SAFETY RECALL

Mack Trucks Inc.
Greensboro, NC USA

Date	Number	Release	Page
06.2026	SC0494	01	1(5)

EPM X3 Connector Exposed AN(4), PR(4)

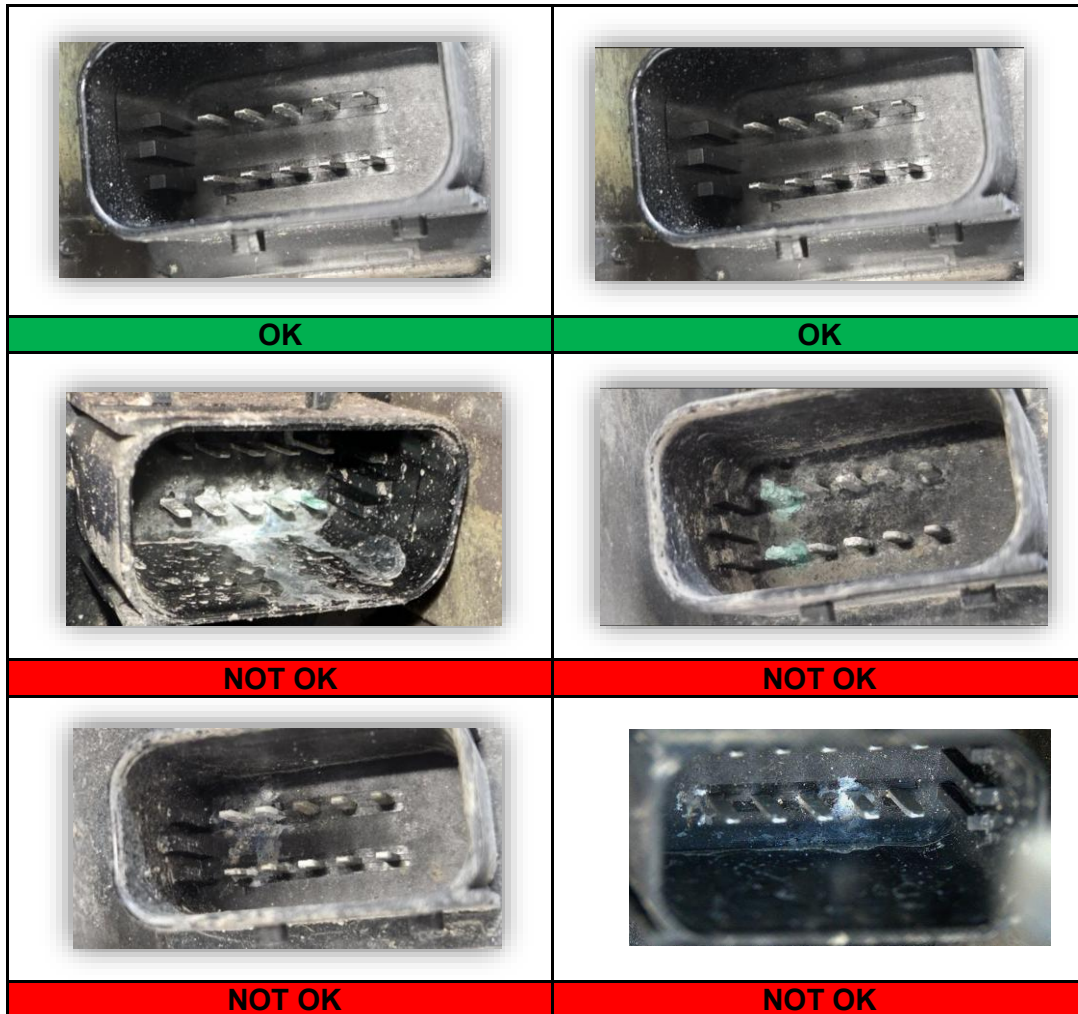
3. Locate the EPM on the rear of the truck. (Driver's side frame rail above the axle).
4. Locate the X3 connector on the EPM and remove the protective cover.

5. Inspect the X3 cavity for any corrosion.
 - a. If corrosion is found in the X3 cavity, continue to **Step 6**.
 - b. If the X3 cavity is free of corrosion, continue to **Step 7**.

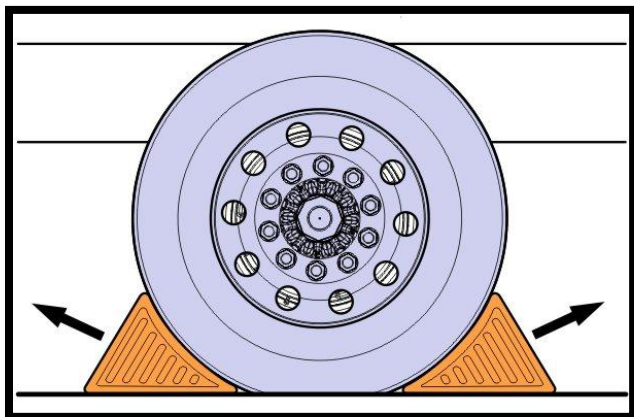
6. Replace the EPM with a new one following Impact operation **5600-03-02-02 Modulator, Rear, Replacement**. Before installing the EPM add the protective cap **995115** to the X3 cavity.
7. Ensure cavity is clean and dry.
8. Install the protective cap **995115** on the X3 cavity.
9. Install and latch the protective cover.
